K.I.S. DRAWINGS No. 11014  
 SCALE DATE OF PREPARED

KING ISLAND SCHEELITE 1947 LTD

PROPOSED DAM SCHEMES  
 GRASSY RIVER R I

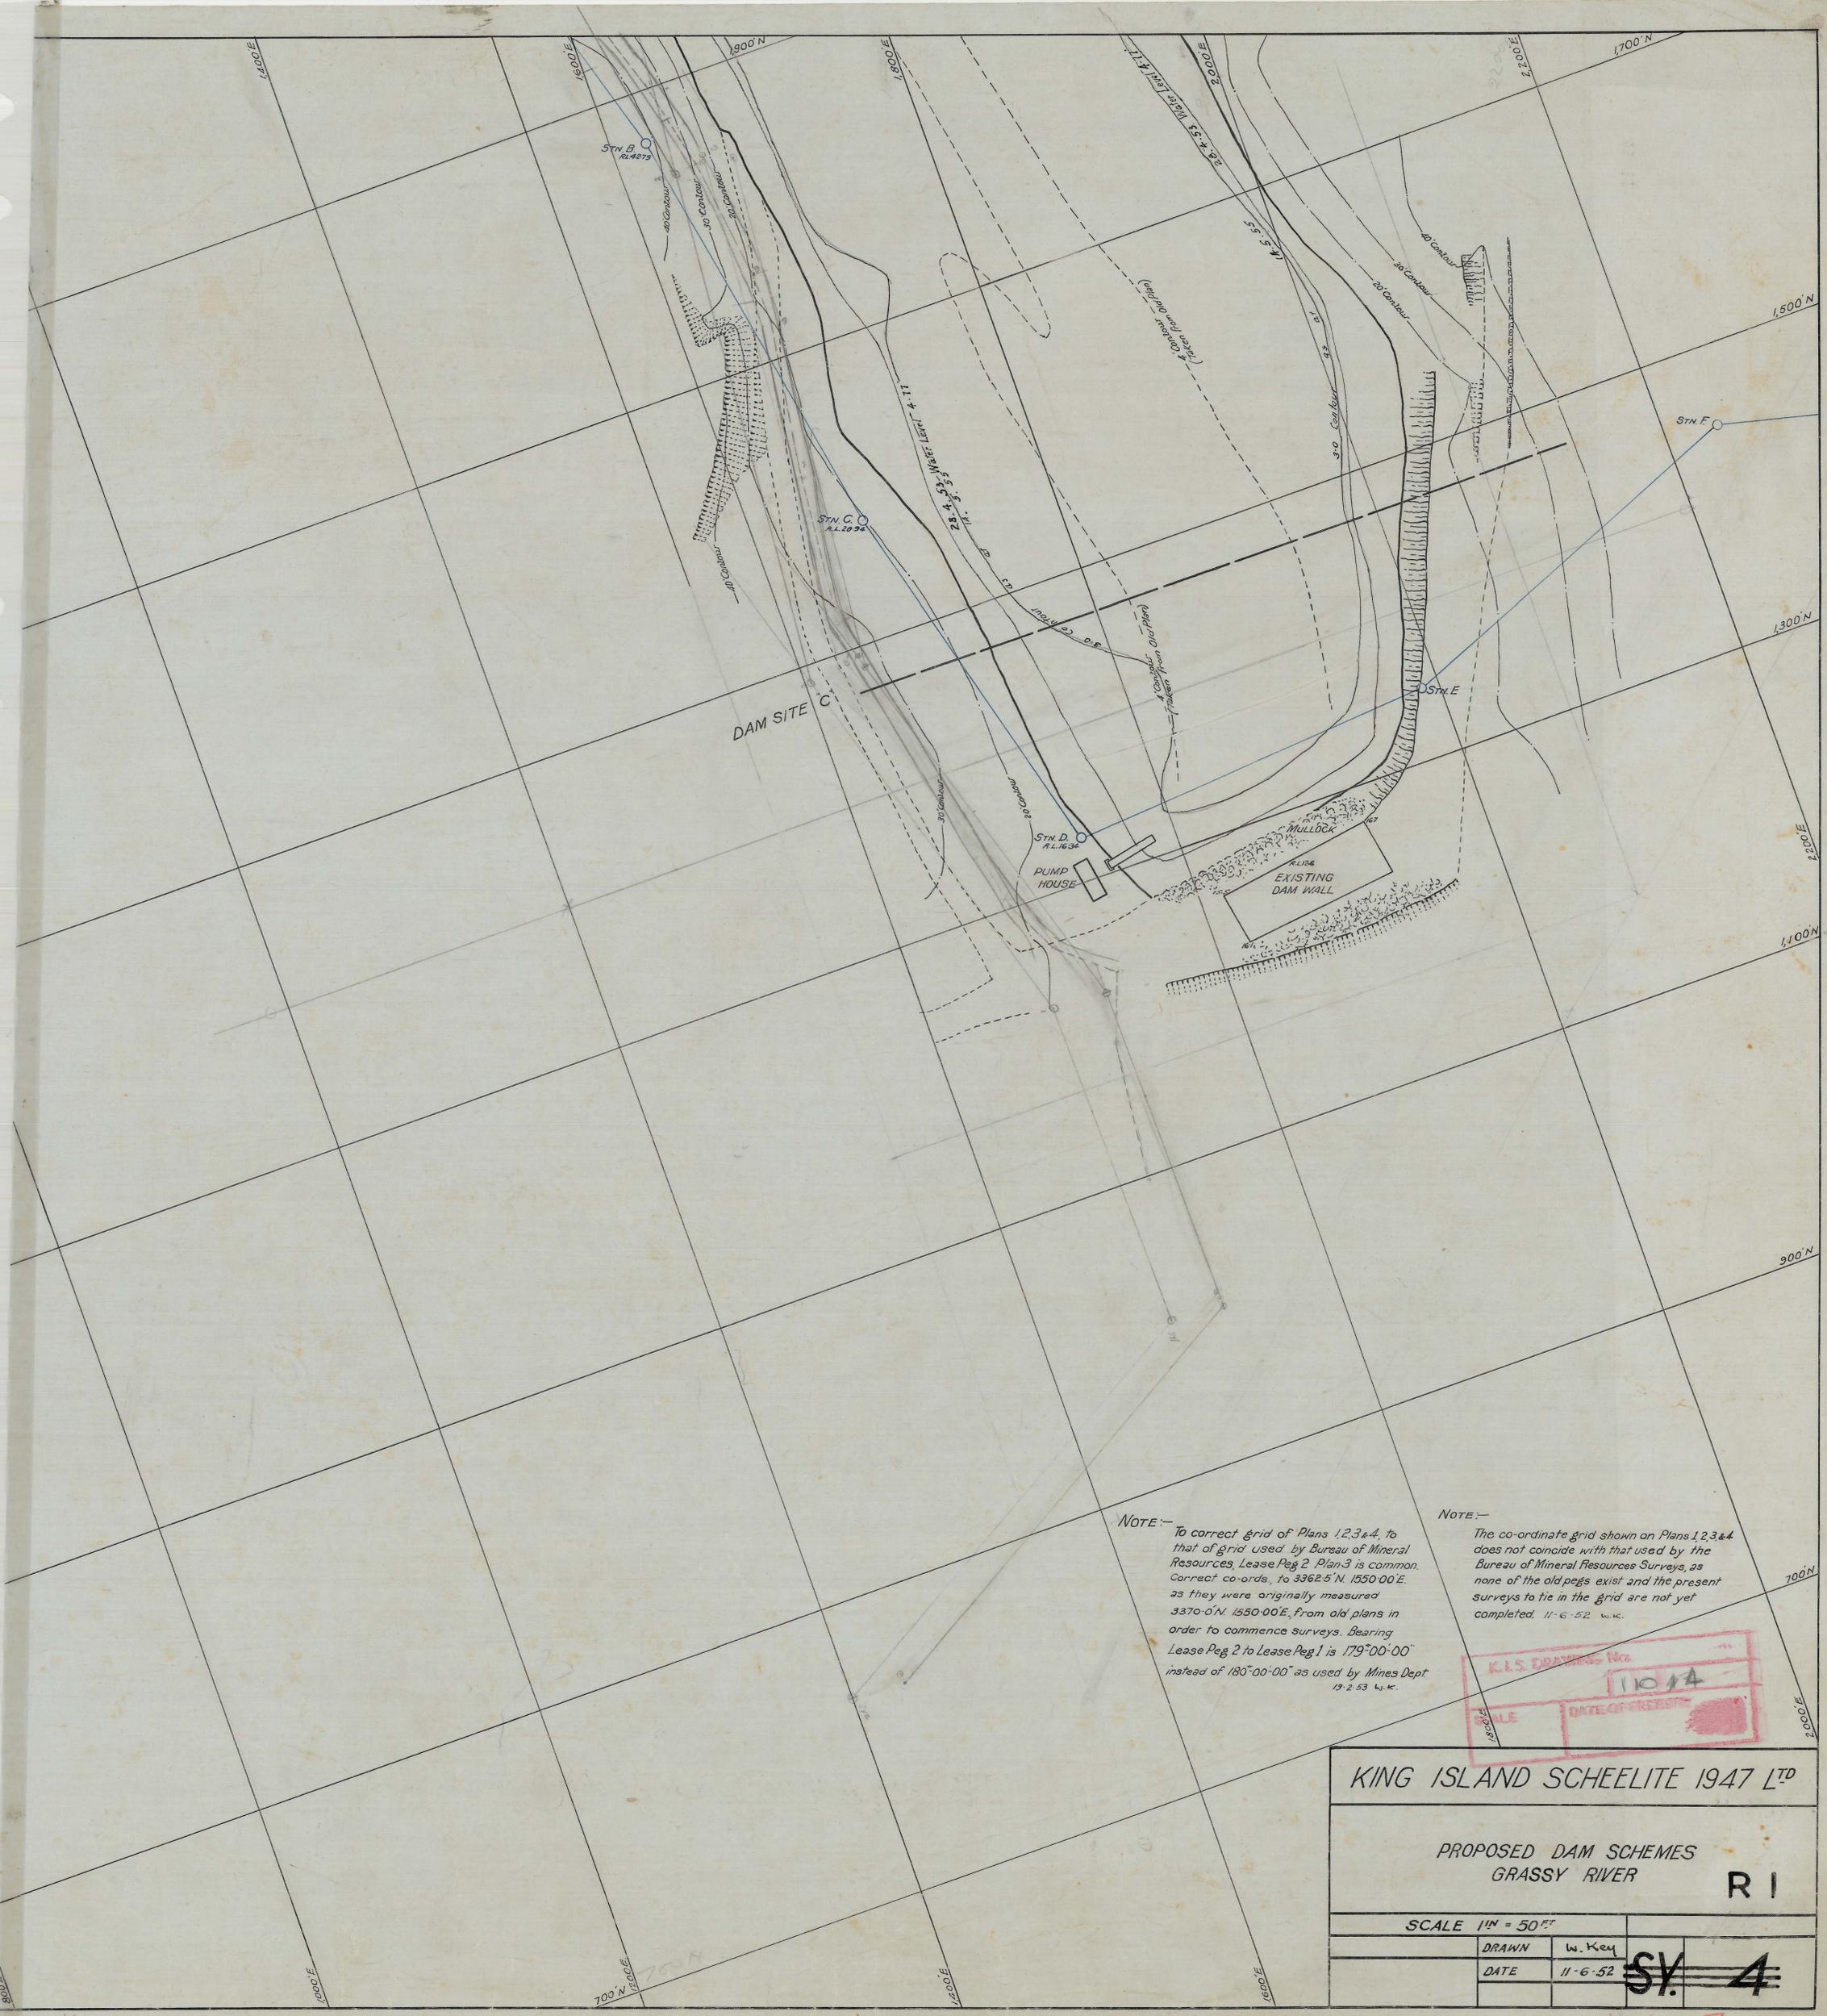
NOTE -  
 To correct grid of Plans 1,2,3&4 to that of grid used by Bureau of Mineral Resources, Lease Peg 2. Plan 3 is common. Correct co-ords. to 3362.5'N, 1550.00'E. as they were originally measured 3370.0'N, 1550.00'E. from old plans in order to commence surveys. Bearing Lease Peg 2 to Lease Peg 1 is 179°00'00" instead of 180°00'00" as used by Mines Dept 13-2-53 W.K.

NOTE -  
 The co-ordinate grid shown on Plans 1,2,3&4 does not coincide with that used by the Bureau of Mineral Resources Surveys, as none of the old pegs exist and the present surveys to tie in the grid are not yet completed. 11-6-52 W.K.
